SAVE CANNOP PONDS TEAM

Reply to

ARUP Downstream Flood Risk - Hydraulic Modelling Results Note

(File reference 292427-ARP-XX-XX-RP-XX-0001)

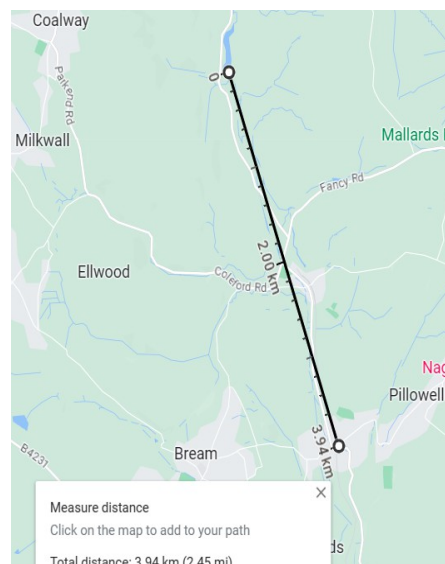
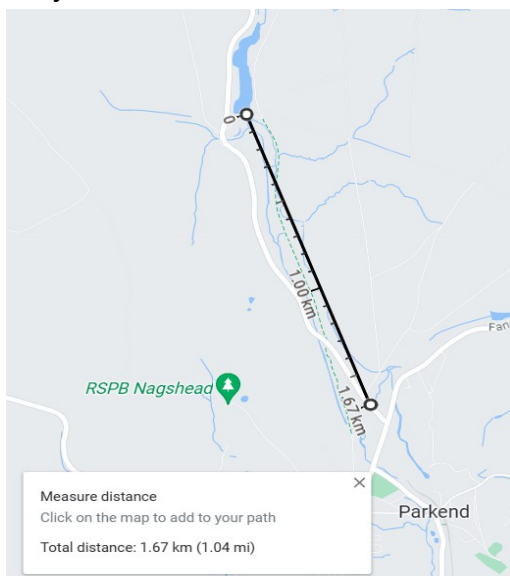
On the Google Maps you can clearly see this is incorrect by a huge margin as it's only 1.67km to the first house on the edge of the village (below left)

4kms downstream is actually the next village, Whitecroft (above right)

You have to ask yourself how accurate ARUP reports can be if they cannot get such a basic fact correct at the very start of their own report !
